Envelope Update Facade

Envelope Update Roof Plant Relocation - Eastern Block

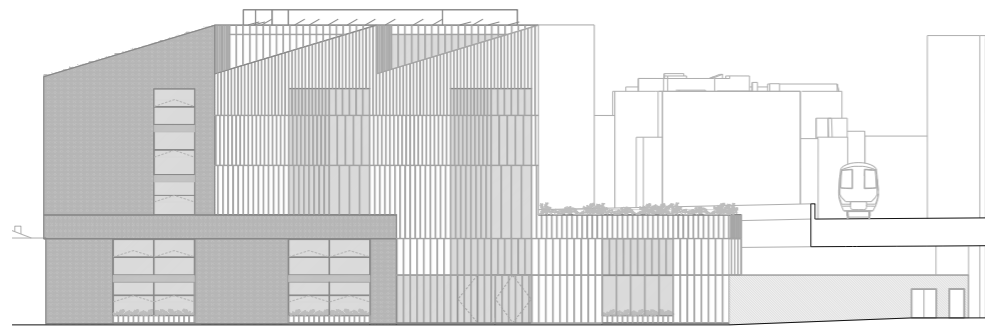
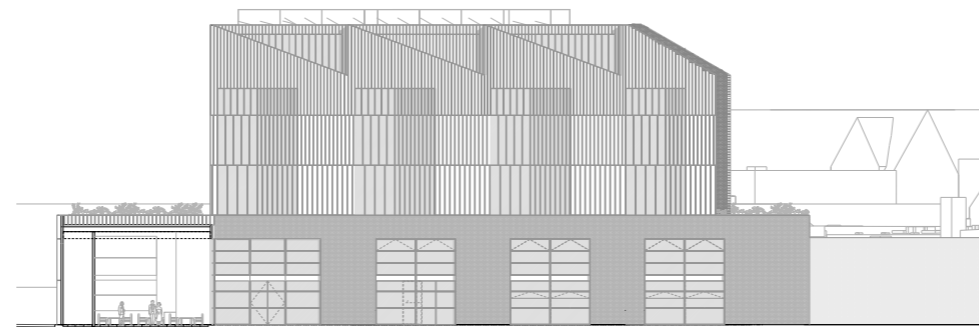
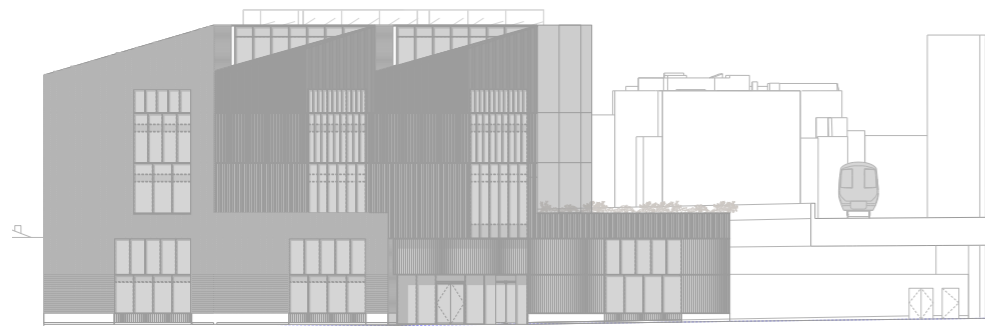
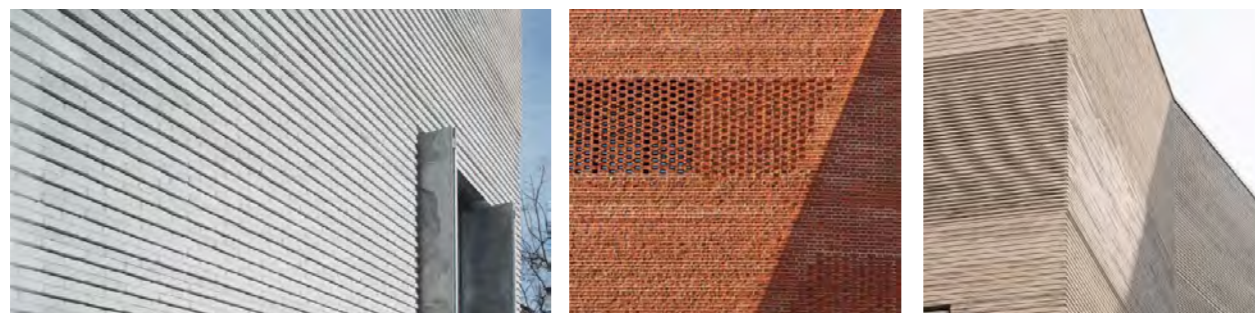
- Increased brick facade to second bay
- Perforated sheet removed from openings to improve internal daylighting
- Rationalised fin arrangement to utilise capped system, improving buildability and enhancing internal daylighting
- Remove hit-miss brickwork over brickwork openings to improve internal daylighting
- Concrete upstand at street level to ensure robustness and longevity of design

Roof plant location as per consented scheme

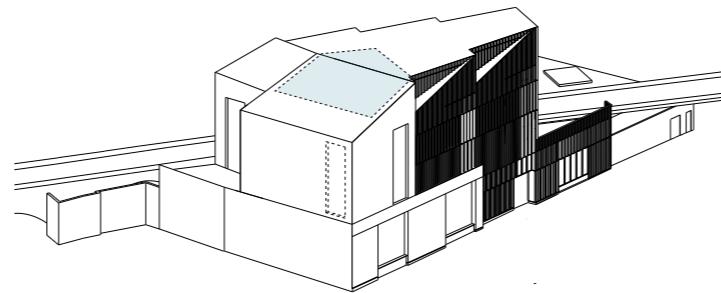
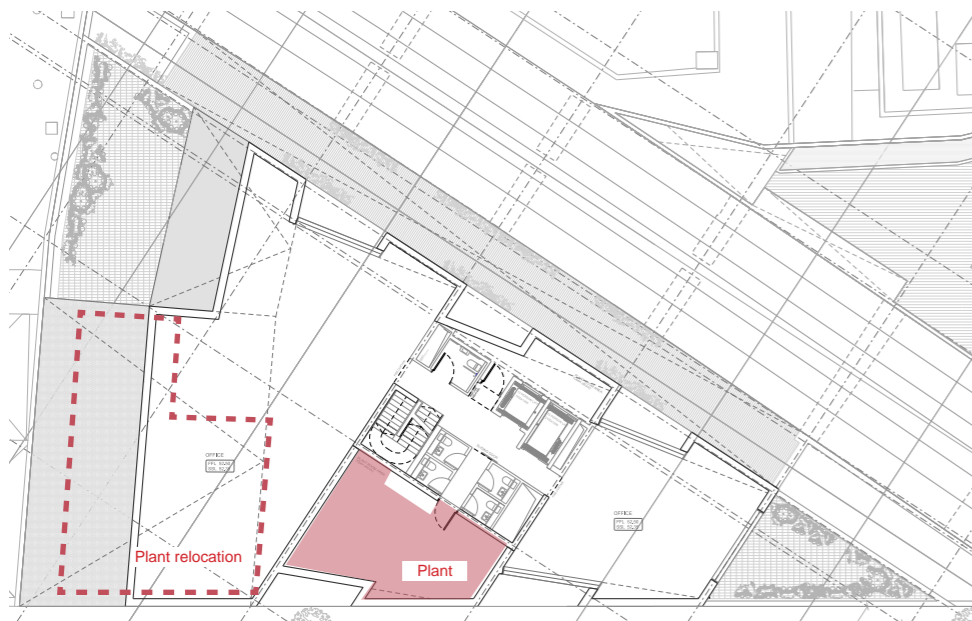
Further development of the MEP requirements for the building allowed for the plant to be relocated from the lightwell on the top floor to the area underneath the pitched roof area. This way the plant is still concealed from sight at street level and the workspace on the top floor is improved, bringing additional daylight into the space.

Proposed plant location concealed under pitched roof
